Re: Turkey Point Unit 3  
Docket No. 50-250  
Order (EA-03-009) Relaxation Request  
Examination Coverage of Reactor Pressure Vessel Head  
Penetration Nozzles

**TURKEY POINT UNIT 3 RELAXATION REQUEST FROM US NRC Order EA-03-009**

**“Hardship or Unusual Difficulty without Compensating Increase In  
Level of Quality or Safety”**

Figure 1: Through-Wall Axial Flaws Located in the 42.6 Degree Row of Penetrations, Uphill Side - Crack Growth Predictions (From Figure 6-19, WCAP-16027-P)

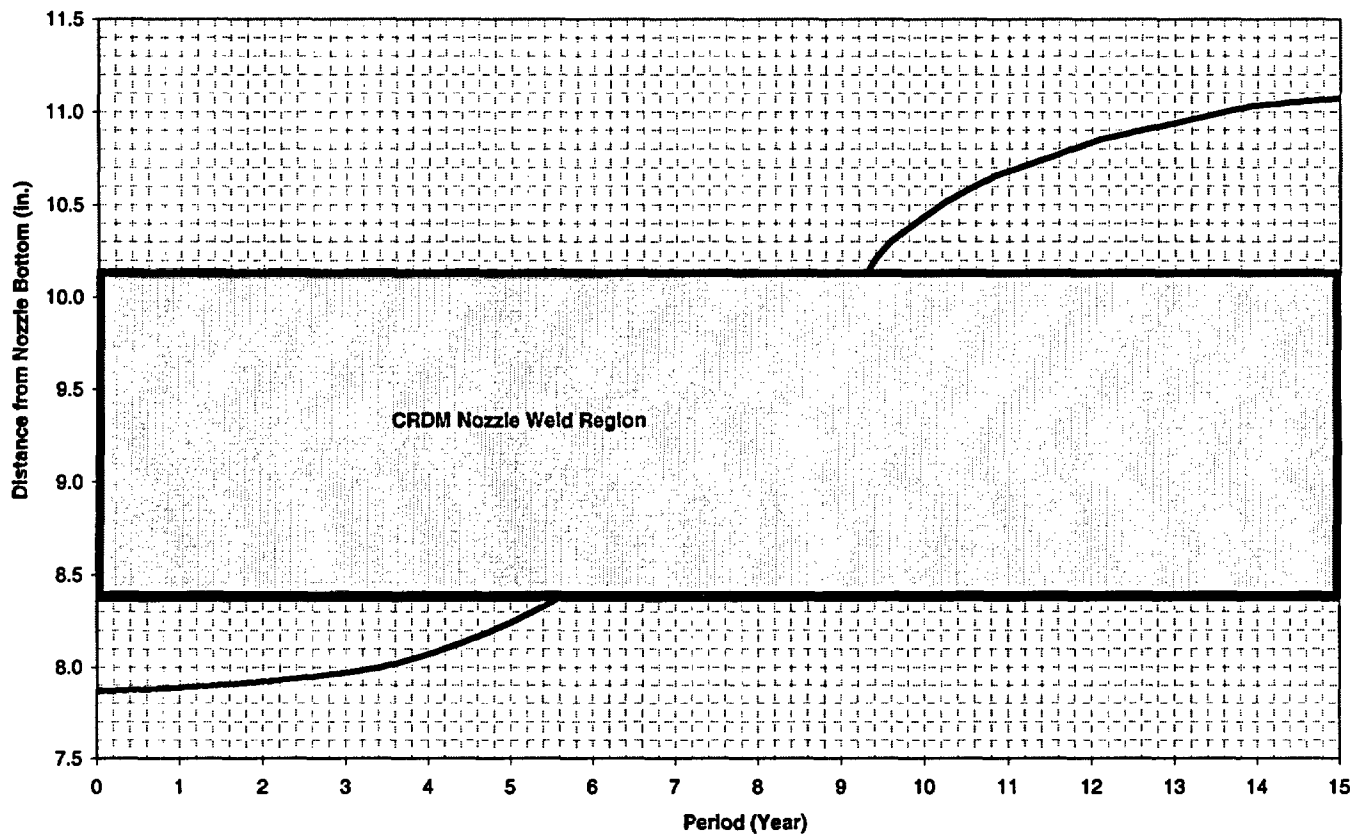
To determine the significance of an axial flaw that is contained in the non-pressure boundary nozzle material in the un-inspected region greater than 1.00 inch below the weld, a flaw tolerance approach is used. A flaw evaluation was performed postulating an axial flaw in the area of missed coverage below the weld using WCAP-16027-P.<sup>5</sup> A through wall flaw is postulated in the nozzle material from the bottom of the penetration to 1.00 inch from the bottom of the weld. This is a conservative assumption since the inspected region extends 0.39 inches farther below the weld on the ID surface of the nozzle. The flaw evaluation in WCAP-16027-P is based on Turkey Point Unit 3 and 4 specific stresses in the nozzle penetrations. Since the stresses in the region, greater than 1.00 inch below the weld, are too low to propagate an axial flaw, the WCAP-16027-P below weld flaw evaluations start at ½ inch below the weld. WCAP16027-P evaluates the time to propagate the postulated flaw in the nozzle to the bottom of the weld (start of the pressure boundary portion of the nozzle material or toe of the J-groove weld). Assuming a through wall flaw below the weld, with the flaw end located at ½ inch below the weld (which is in the area of complete UT examination coverage), an axial flaw would take greater than 5 years of operation (Figures 6-12 through 6-20 in WCAP-16027-P) in any nozzle location to grow to the point of contact with the weld. This time period is significantly greater than the current inspection frequency of every refueling cycle

(18 months for Turkey Point Unit 3) identified in NRC Order EA-03-009. As an added conservatism, this evaluation does not attempt to evaluate the time for the axial flaw to grow from the bottom of the weld through the pressure boundary. Figure 1 provides a graphical presentation of the above flaw evaluation discussion for the outer most penetration location (most limiting case).
